## ADDENDUM #3

**Date Issued: March 27, 2018**

**NEW HAVEN PUBLIC SCHOOLS  
SCHOOL CONSTRUCTION PROGRAM**

**5 NORTH PENTHOUSE @ D LINE**  
1 1/2" = 1'-0"

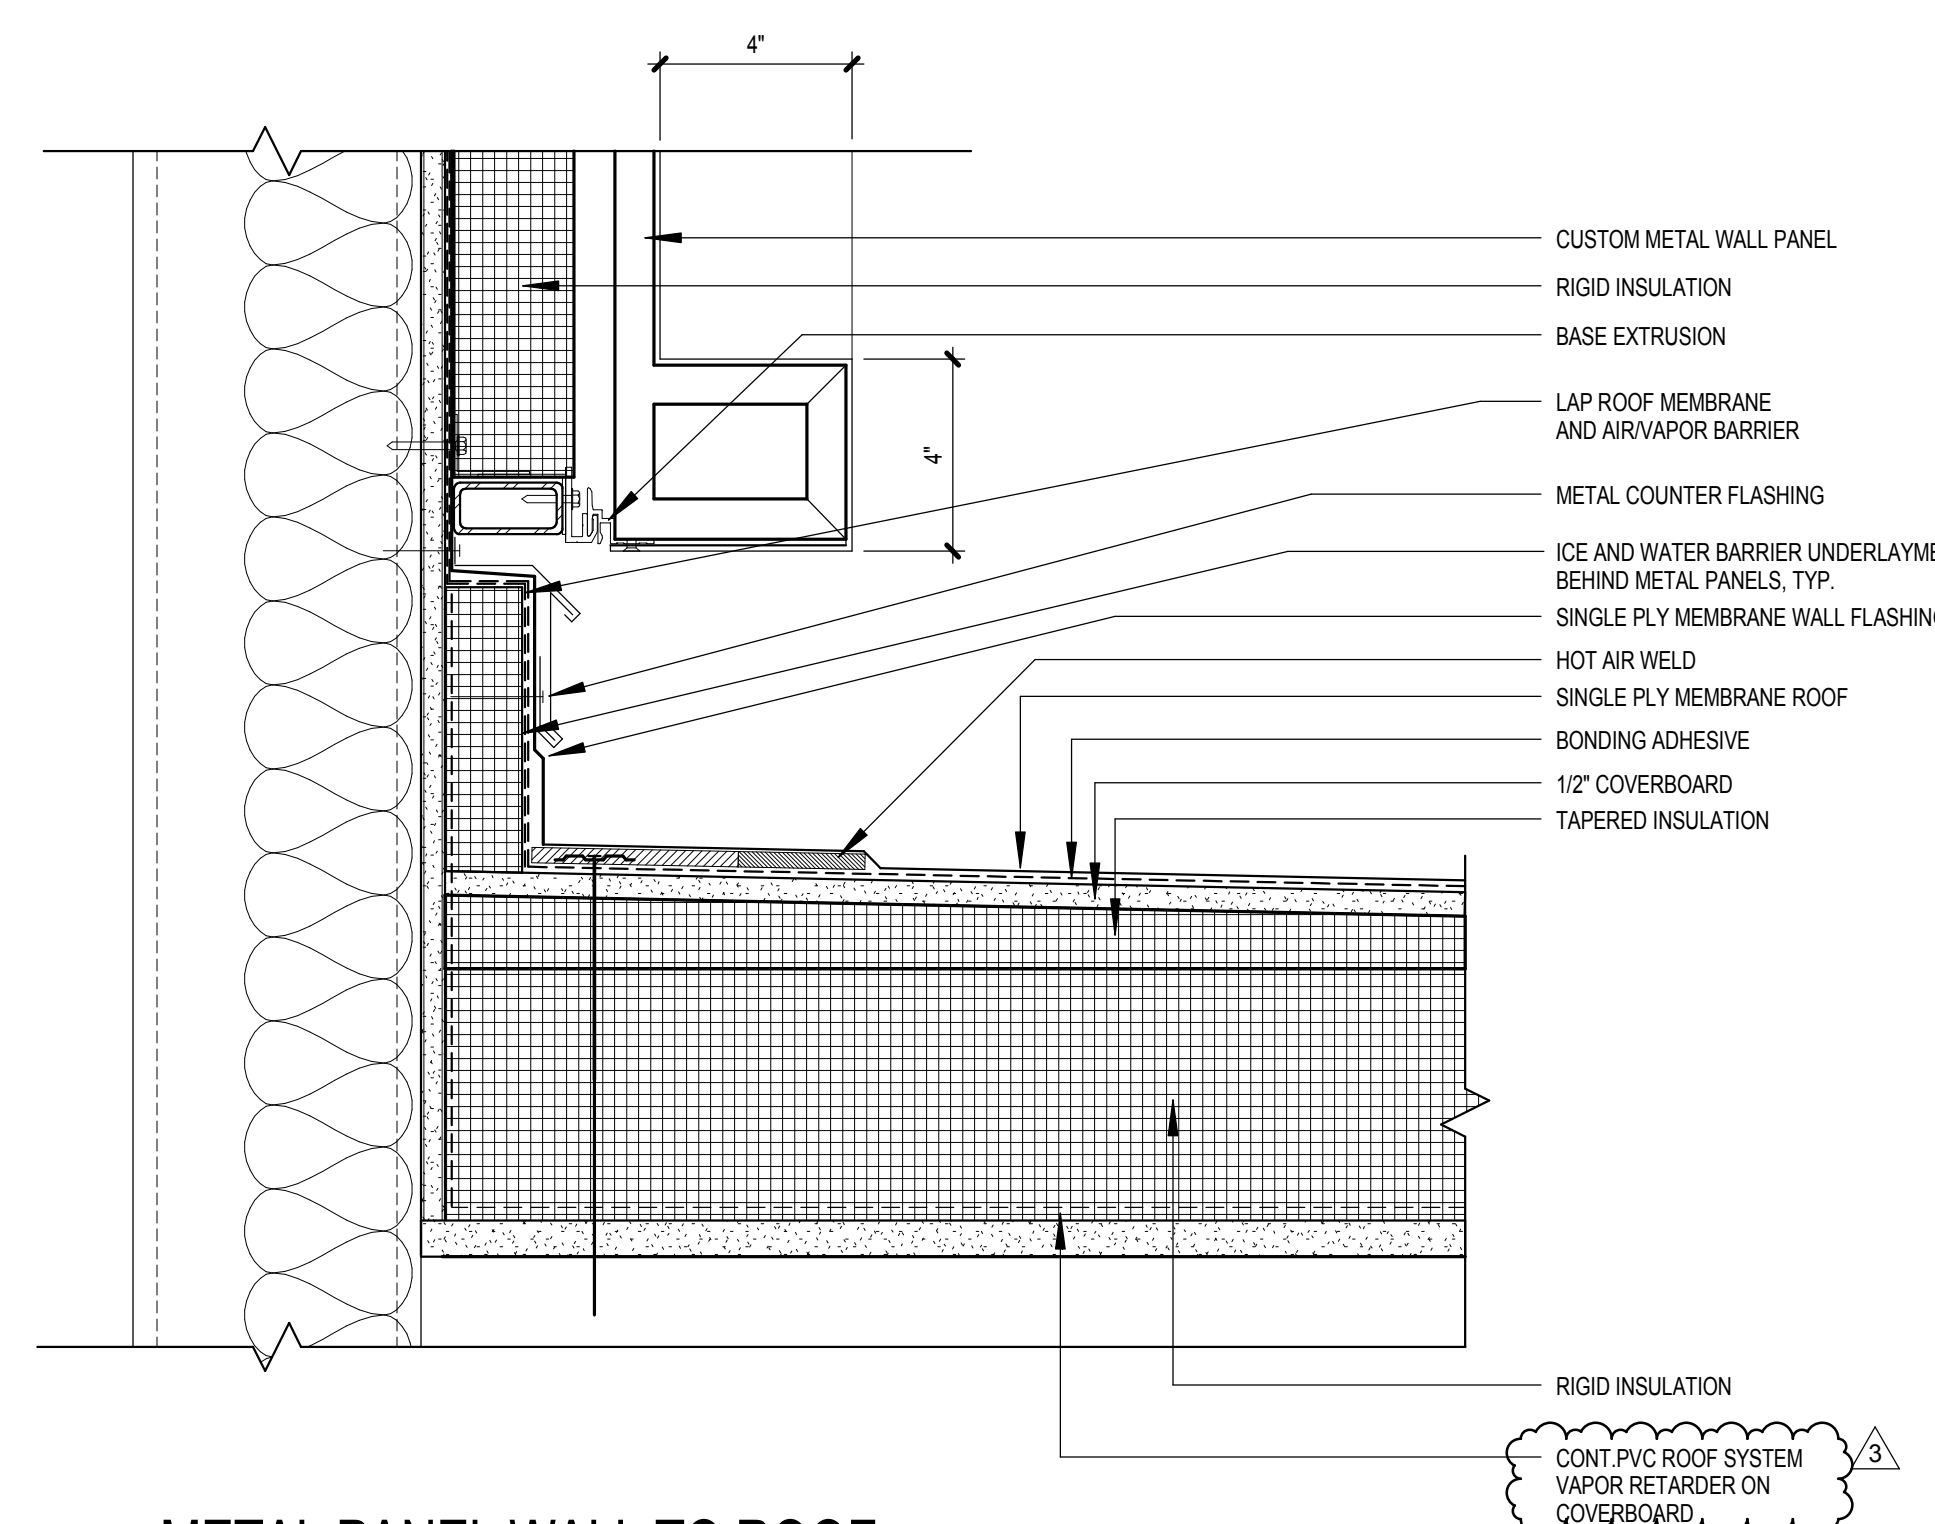
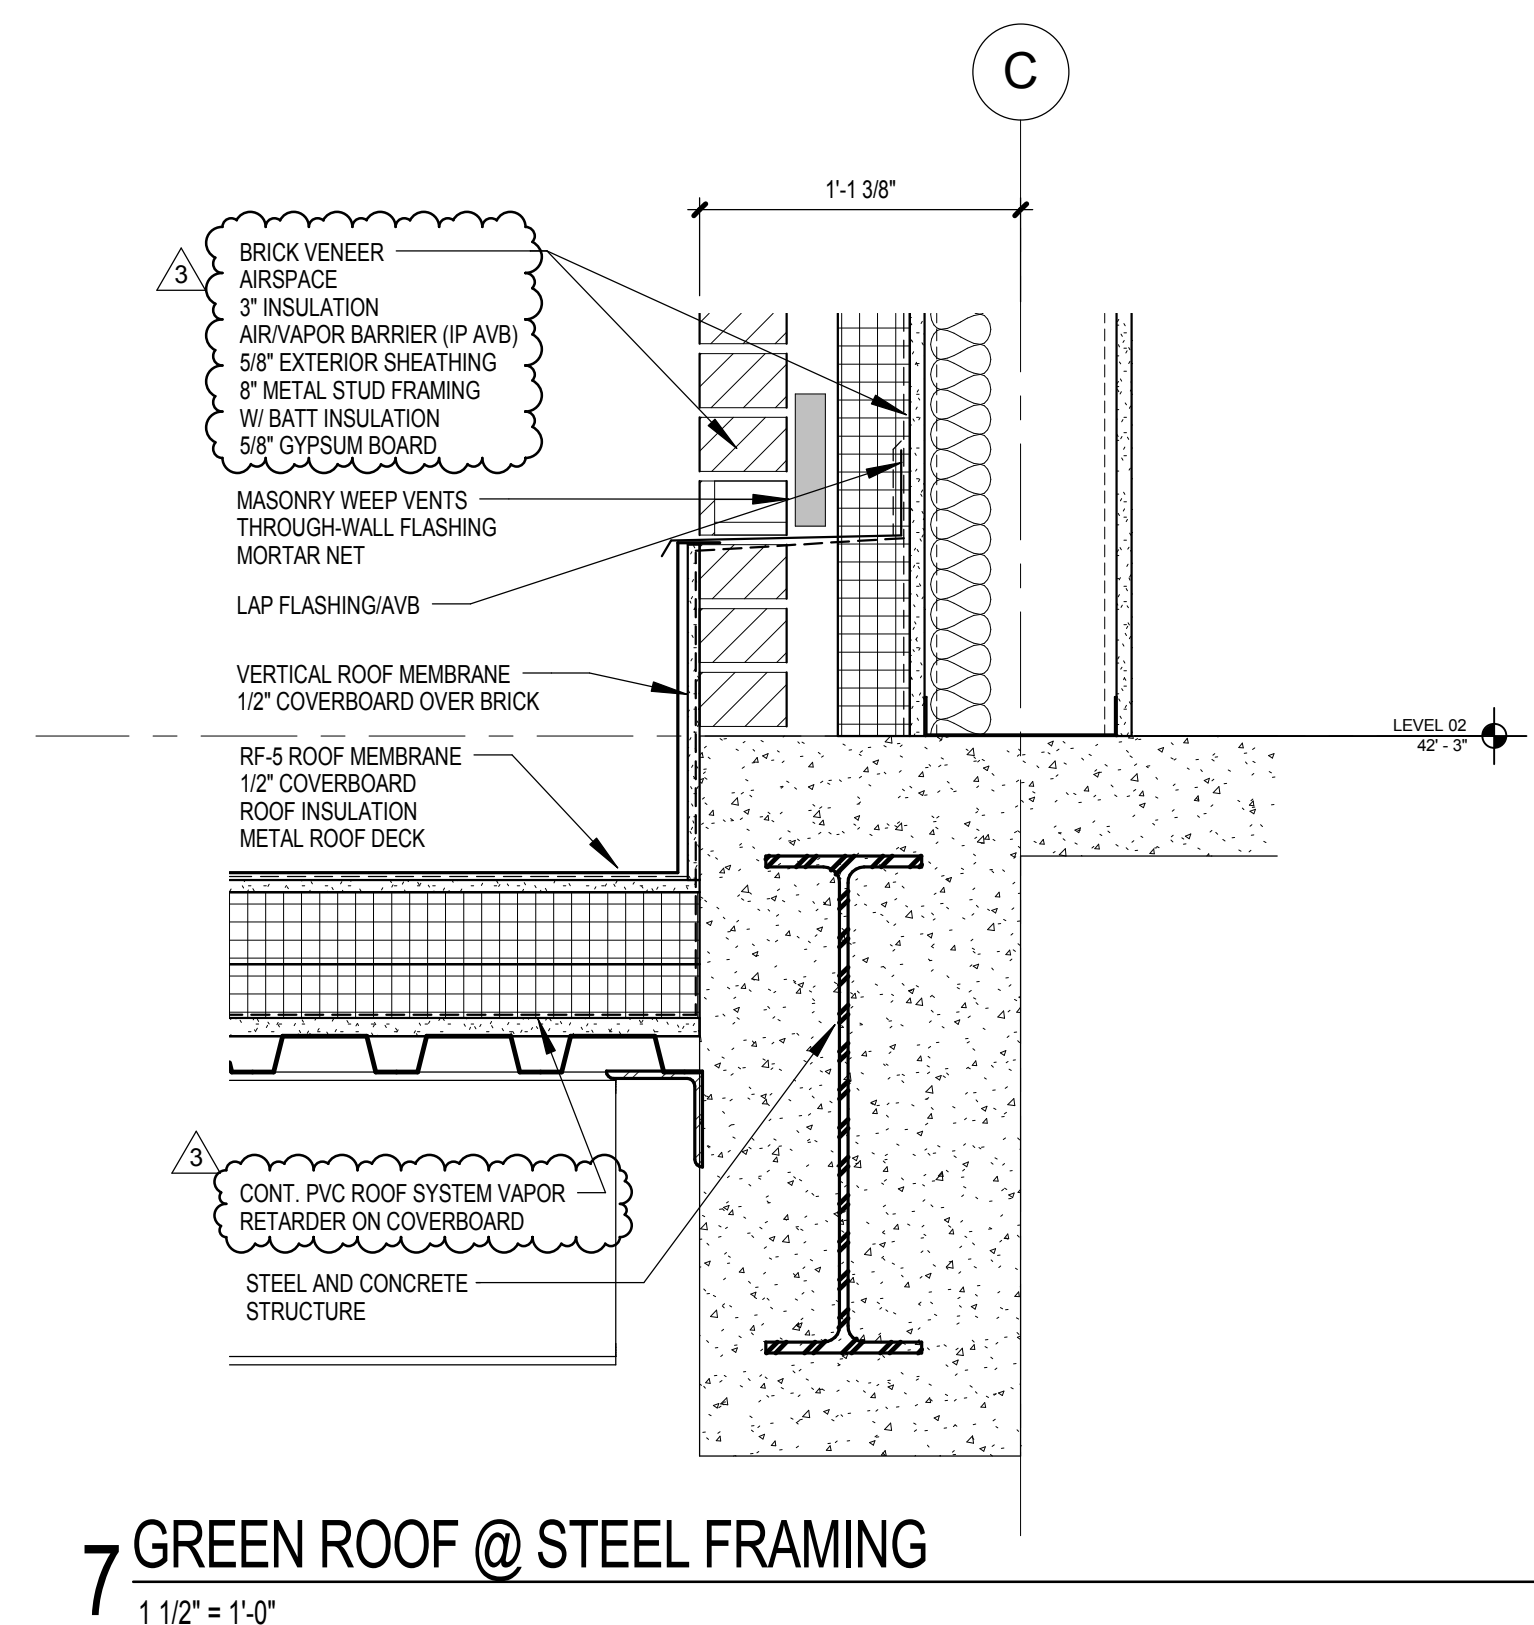
- A-520: Revised details to clarify roof system AVB
- A-521: Revised details to clarify roof system AVB
- A-522: Revised details to clarify roof system AVB

Can you please confirm the "VP Vapor barrier" as shown in typical detail 4/A521 is by others and the "IP Vapor barrier" is by the roofer?

12. A-521: Revised details to clarify roof system AVB
13. A-522: Revised details to clarify roof system AVB
14. A-550: Modified details 13, 16 & 18 to indicate correct ceiling type.

**A-550**

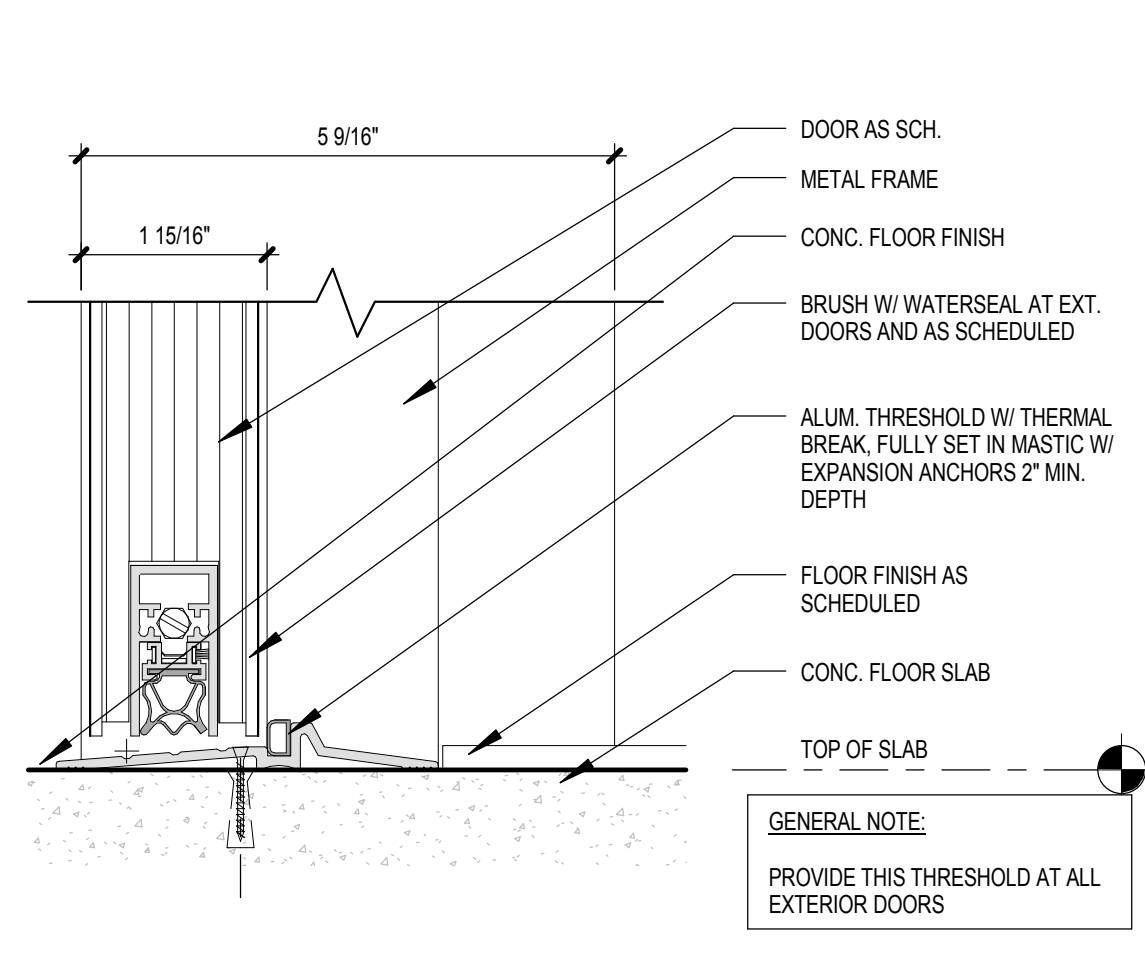
- A-550: Modified details 13, 16 & 18 to indicate correct ceiling type.
- A-550: Added detail 21 for soffit condition at east gym/café curtain wall.
- A-560: Revised glazing type in frame type C.

2. The soffit details along the east walls in the gym/café have been revised. Refer to revised A-327 & A-550 issued in this addendum.

15. A-550: Added detail 21 for soffit condition at east gym/café curtain wall.
16. A-560: Revised glazing type in frame type C.
17. A-560: Modified detail 4 to indicate correct ceiling type.

**M-112**

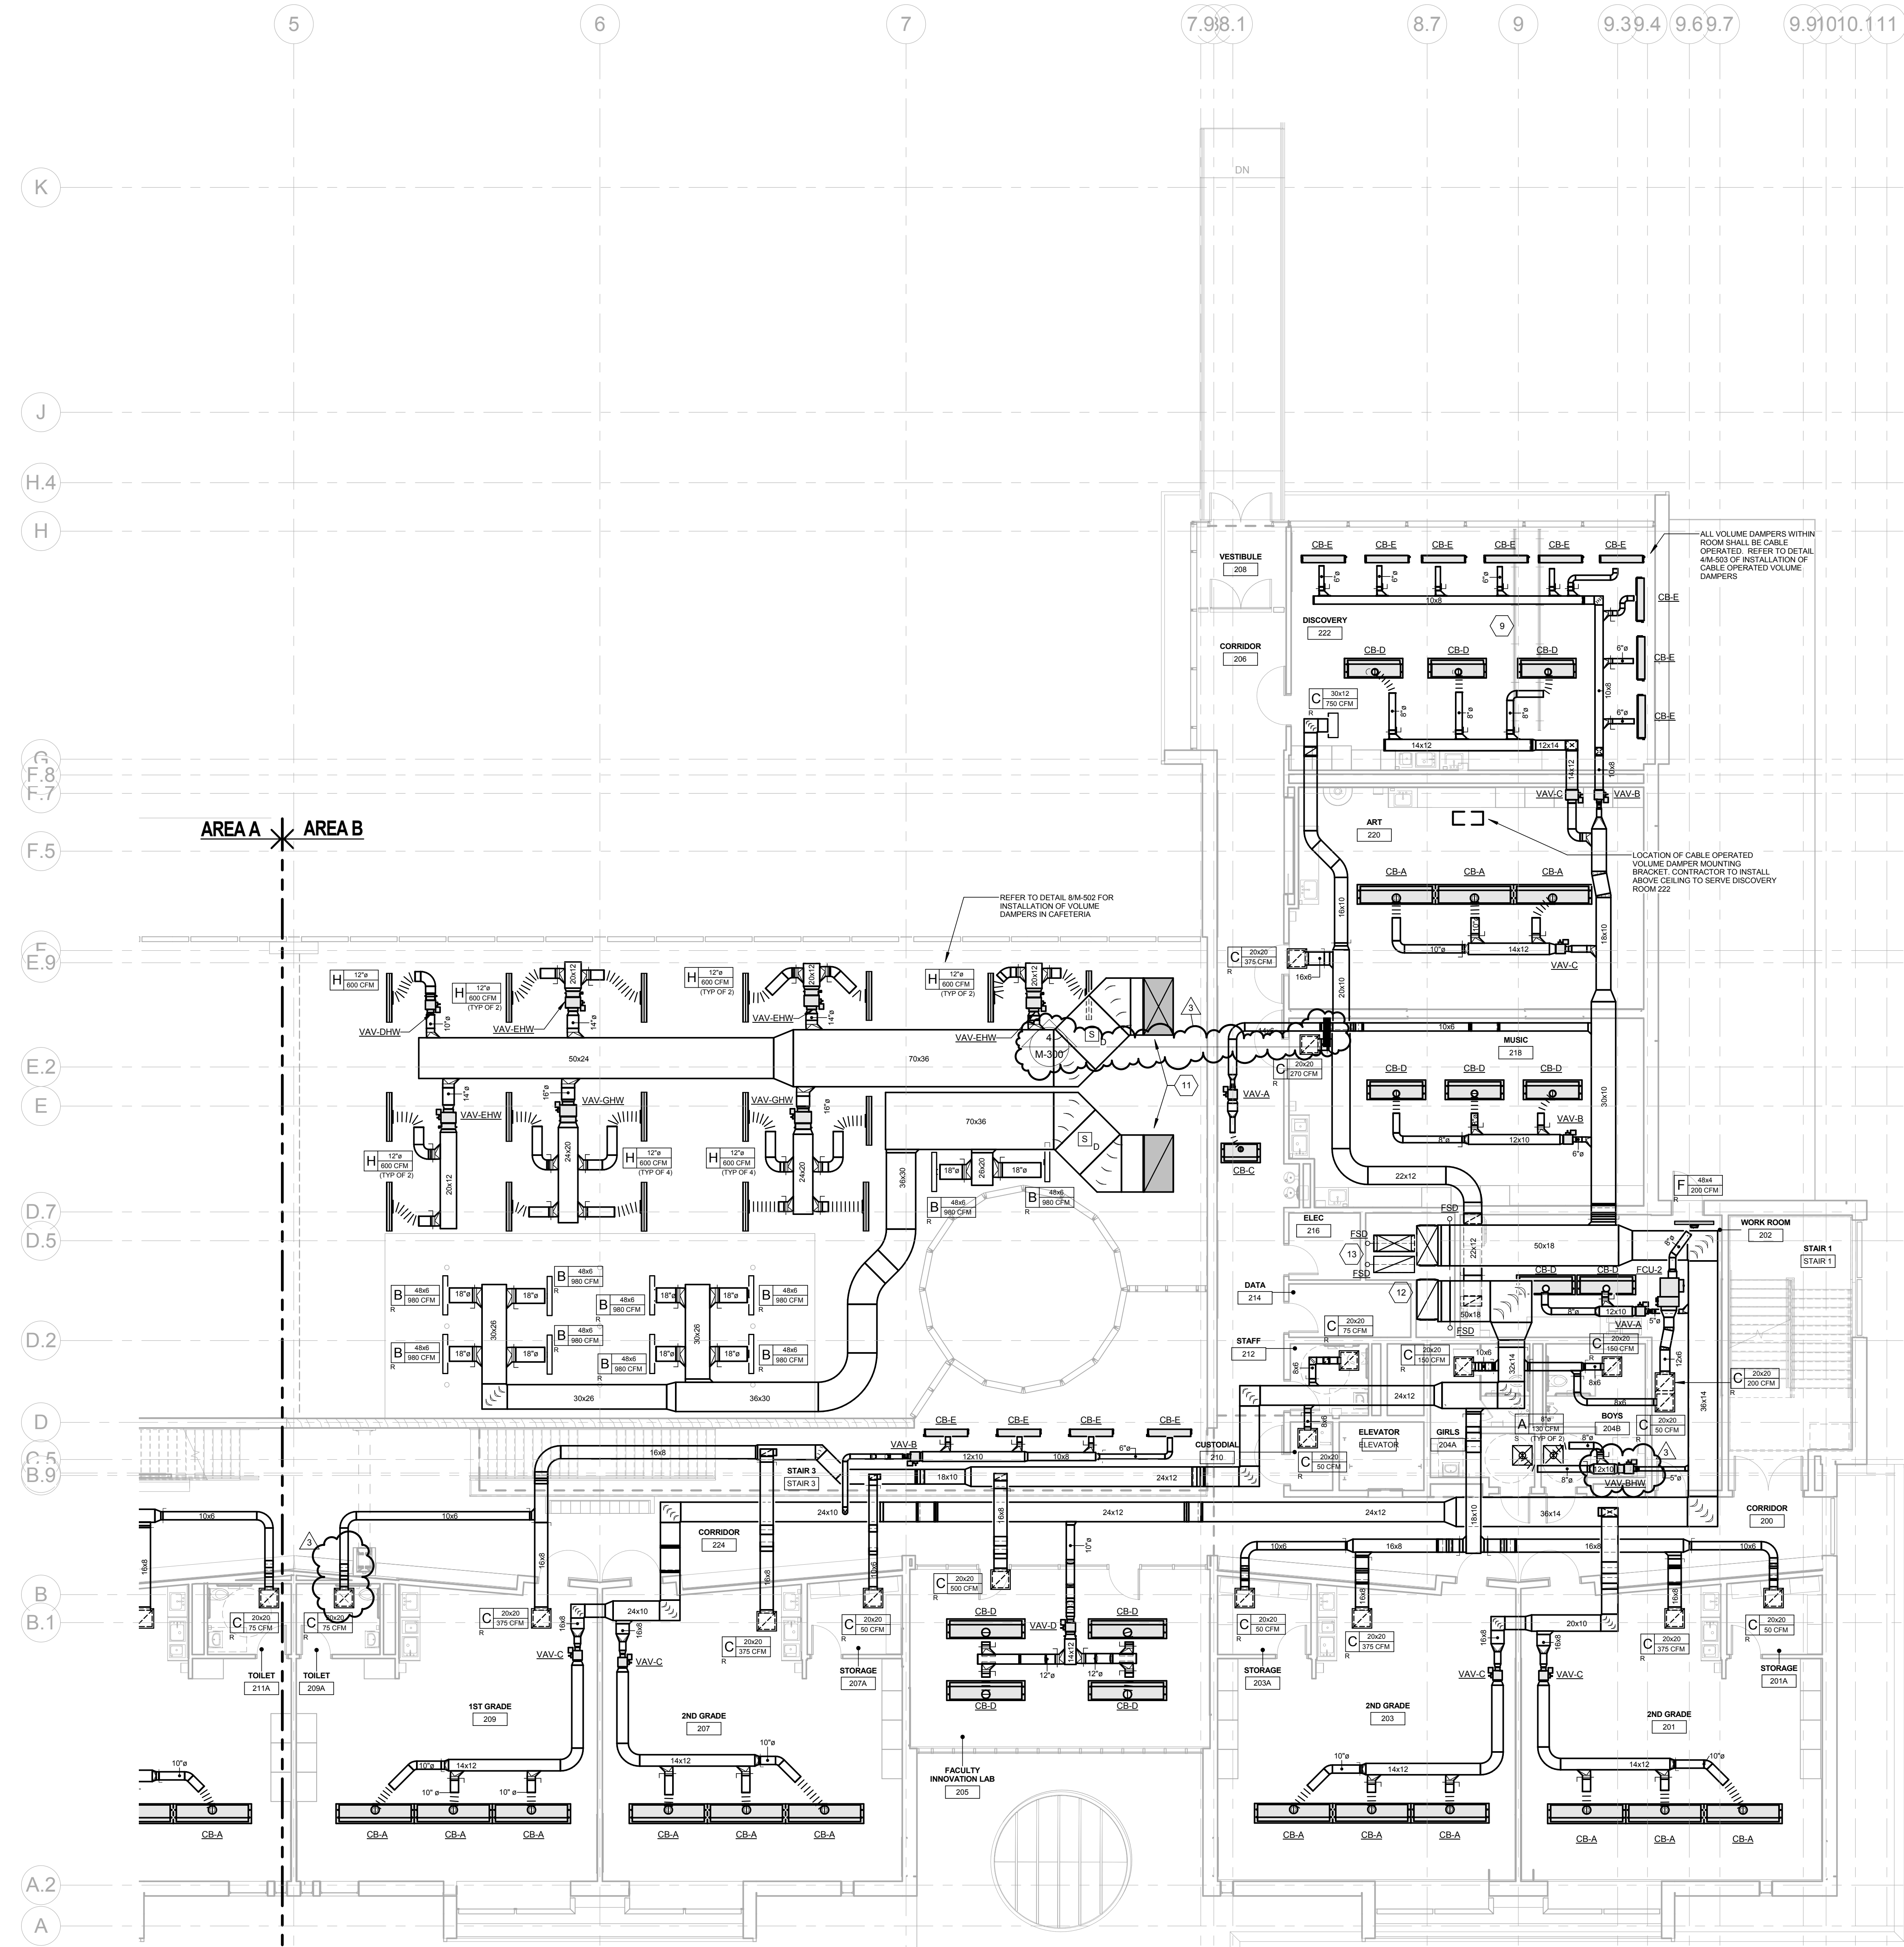
1. Women 110 and Men 112
  - **CLARIFICATION:** Drawing M-112 & MP-112 VAV box serving Women 110 and Men 112 shall be type VAV-DHW.
  - **ADD:** 1” Hot water supply and return piping to serve VAV-DHW within Women 110 and Men 112 .

2. Women 110 and Men 112
  - a. **CLARIFICATION:** Drawing M-112 & MP-112 VAV box serving Women 110 and Men 112 shall be type VAV-DHW.
  - b. **ADD:** 1" Hot water supply and return piping to serve VAV-DHW within Women 110 and Men 112 .
